Zoning & Subdivision Committee

Staff Report – Glacier Park Neighborhood Section 13

PRELIMINARY PLAT & PLANS FOR

COURTYARDS ON HYLAND RUN

RESIDENTIAL STREETS
50' R/W (NO PARKING)

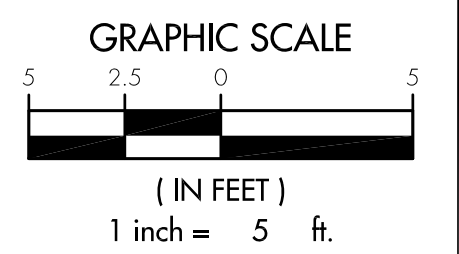
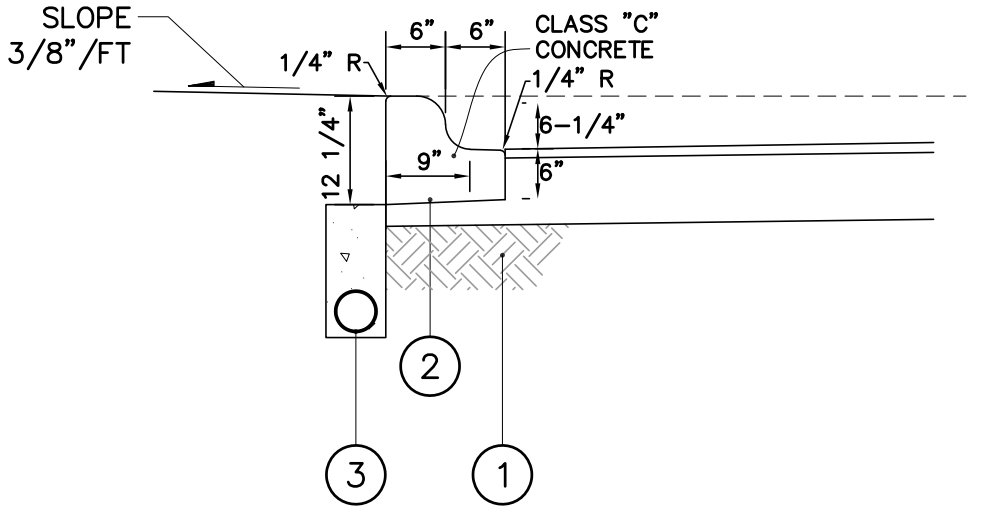
VARIANCE TO UNION COUNTY TECHNICAL DESIGN STANDARDS, ARTICLE 2, SECTION 202 - RIGID PAVEMENTS - THE PROPOSED STREET SECTION IS 6" OF ROLLER COMPACTED CONCRETE, CAPPED WITH 1.5" OF SURFACE ASPHALT. WE REQUEST TO REMOVE THE 4" AGGREGATE BASE.

PROJECT NO.: 19018
DATE: SEPTEMBER, 2019
SCALE: HORIZONTAL: 1" = 50'
VERTICAL: N/A
SHEET NO.: 3/17

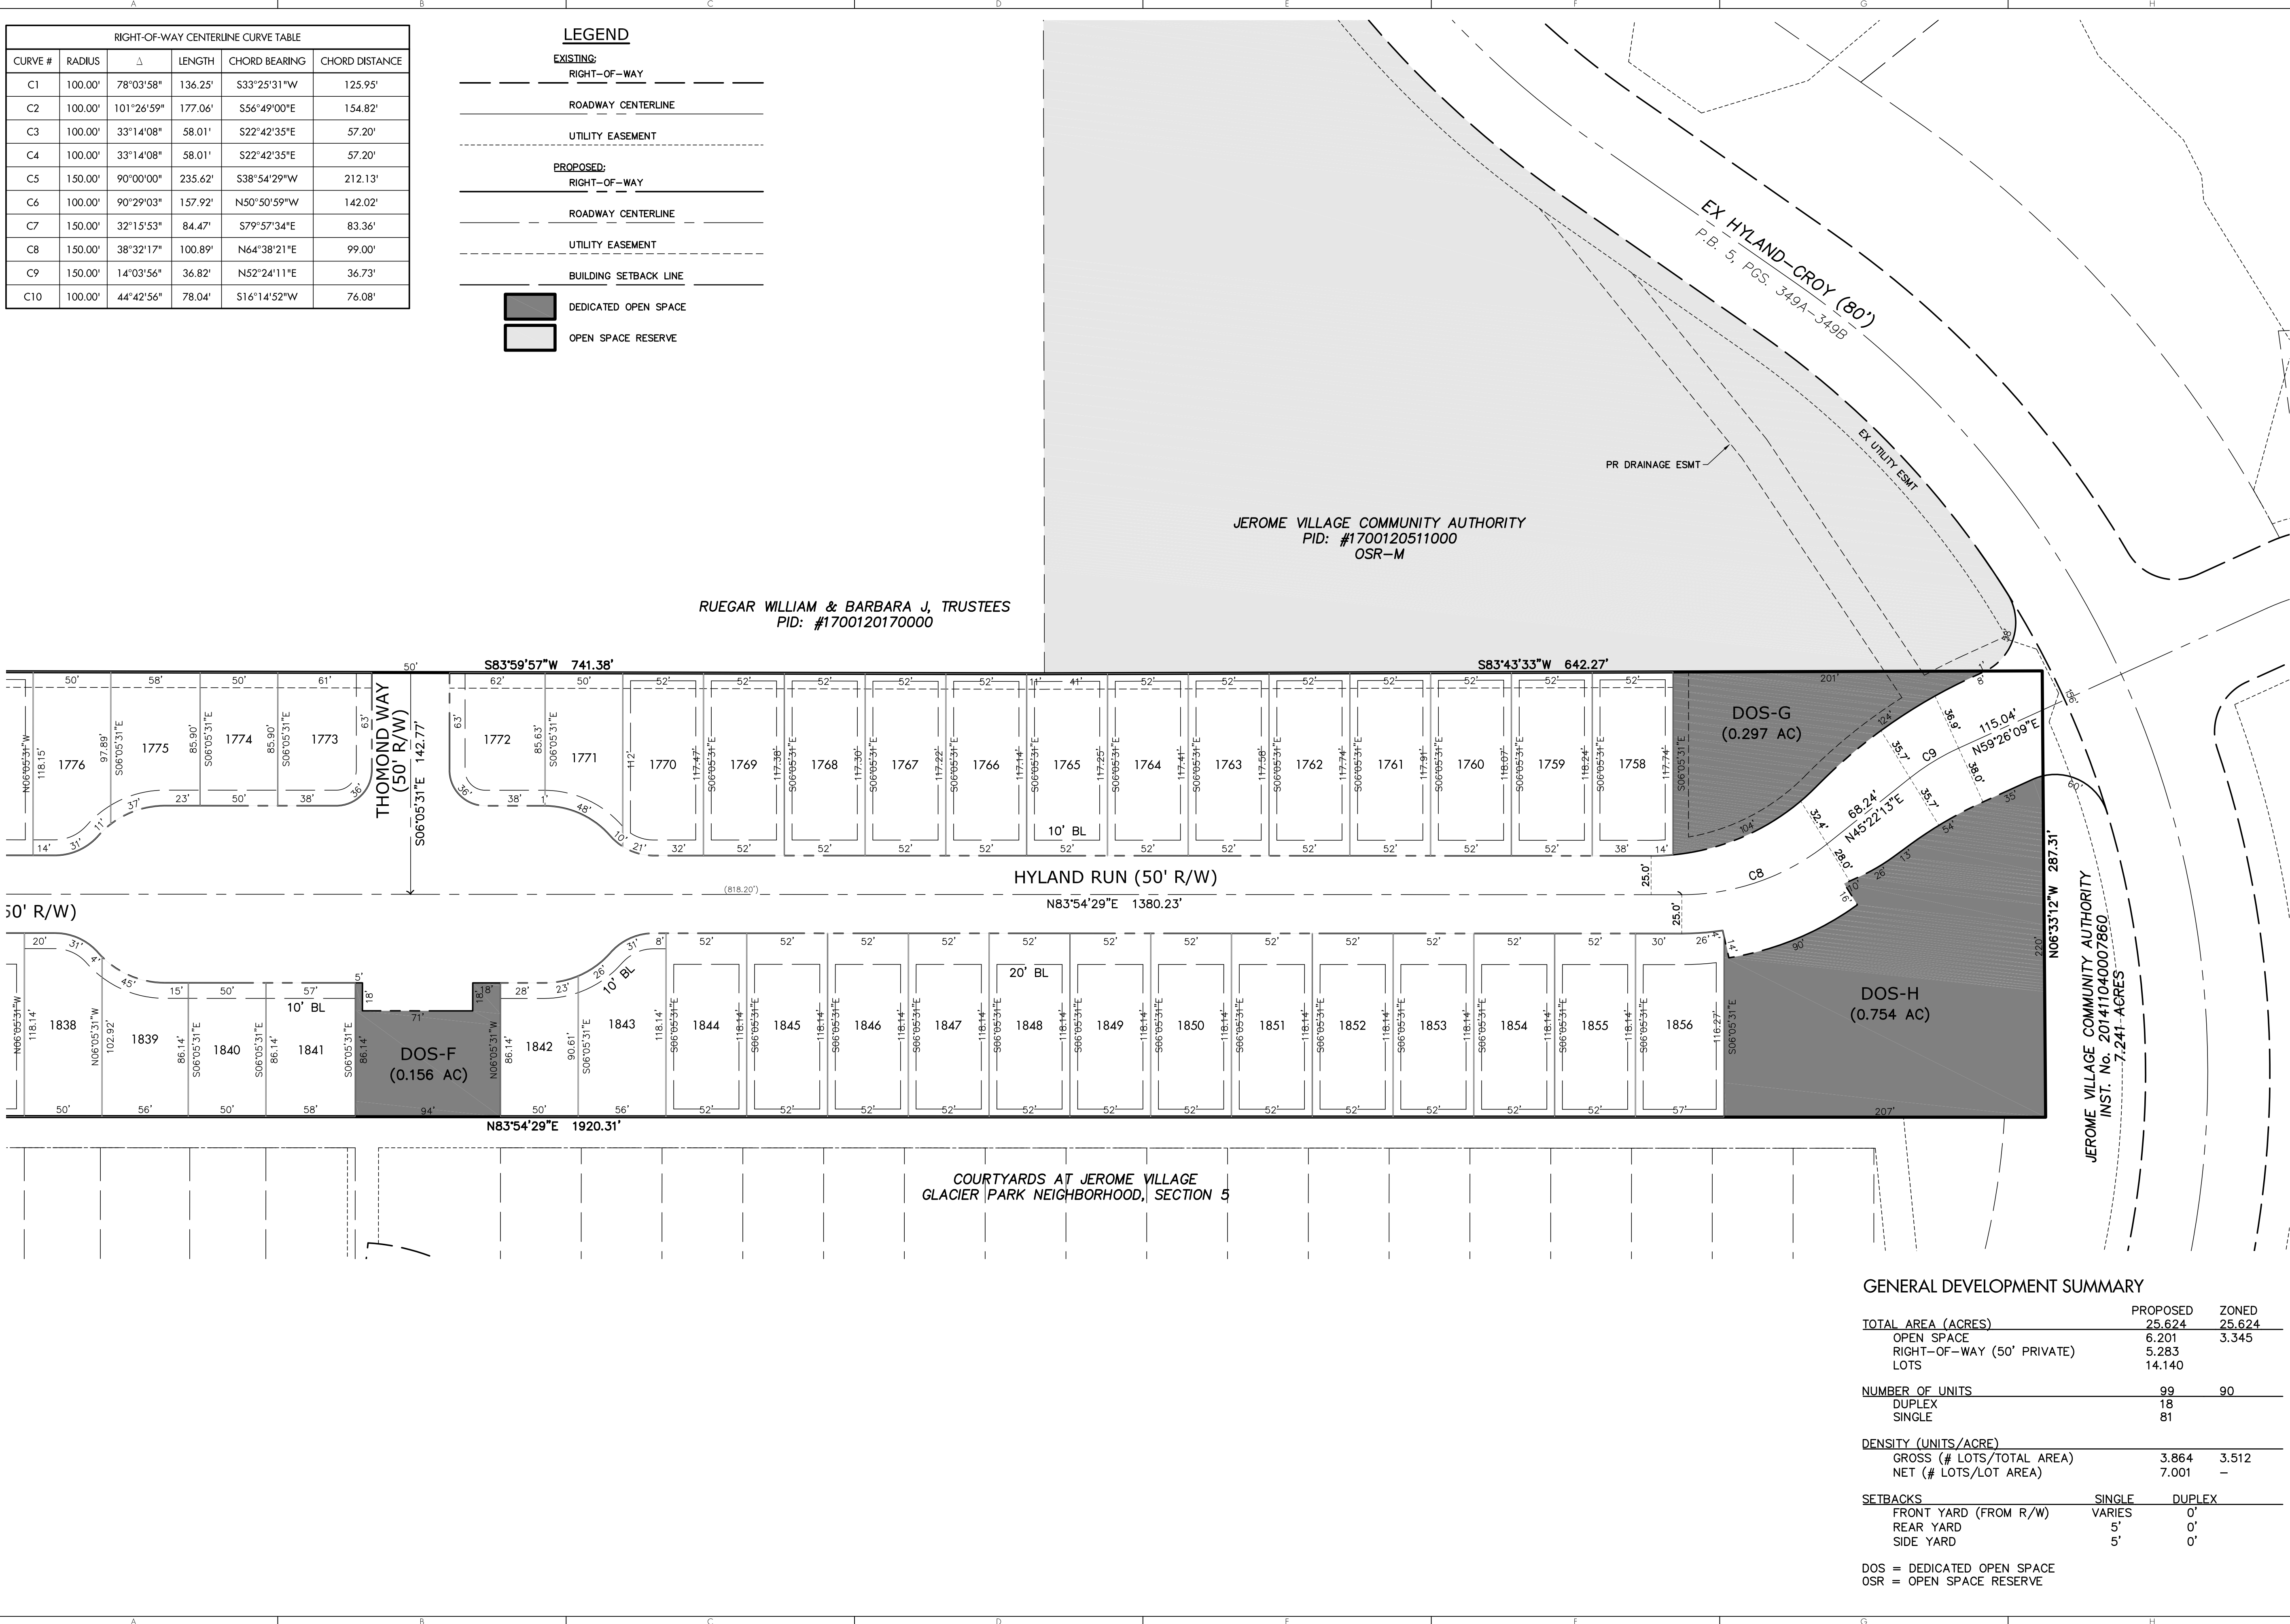
- a) No comments
- 3) Sheet 3 of 17
 - a) Building set back from lot 1777-1783 encroaches in easement area
 - b) Building set back from lot 1797-1806 encroaches in easement area

PROJECT NO.: 19018
 DATE: SEPTEMBER, 2019
 SCALE: HORIZONTAL: 1" = 50'
 VERTICAL: N/A
 SHEET NO.: 4/17

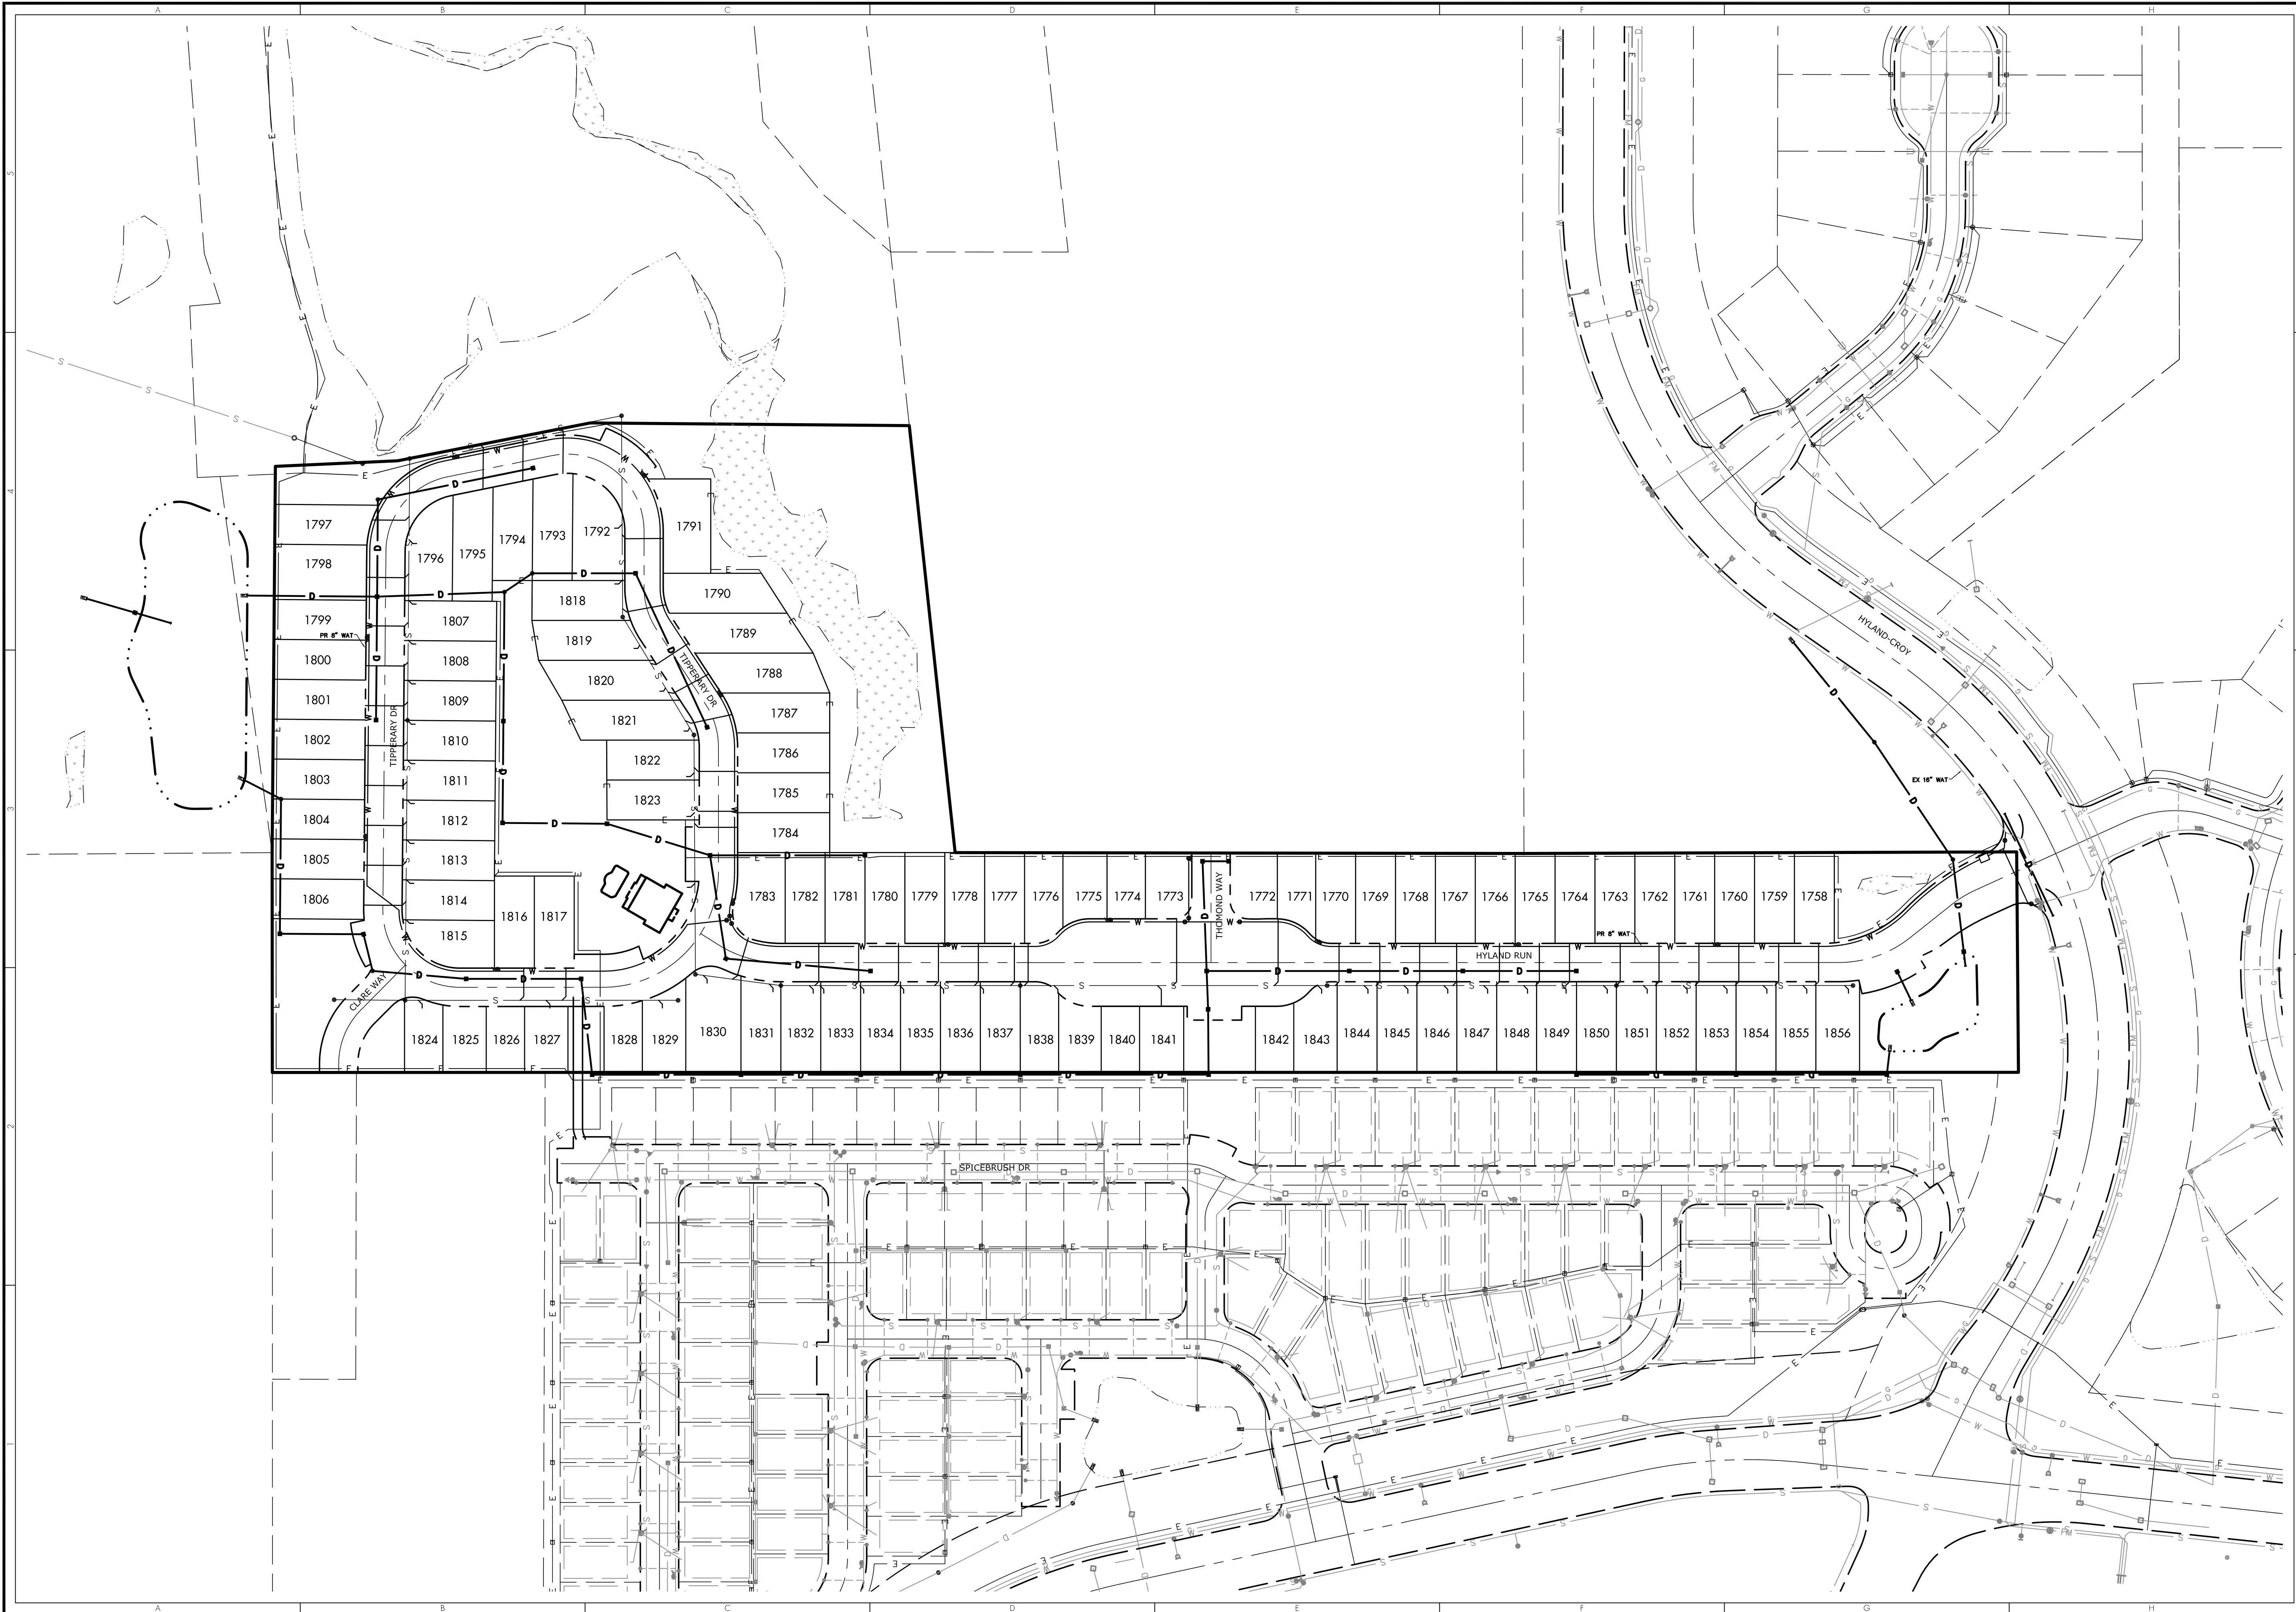
- 4) Sheet 4 of 17
 - a) Building set back from lot 1758-1770 encroaches in easement area
 - b) URE has easement requirements of 20 feet for underground primary and secondary facilities. Actual location of electrical facilities can be located within a 10 feet easement if adjacent property has additional easements or right of way for ingress and egress totaling a minimum of 20 feet. When on property line require 10 ft easement on each of the adjacent properties. Developer to install creek/stream crossing (directional bore if applicable) 10 feet beyond stream protection easements (when applicable)
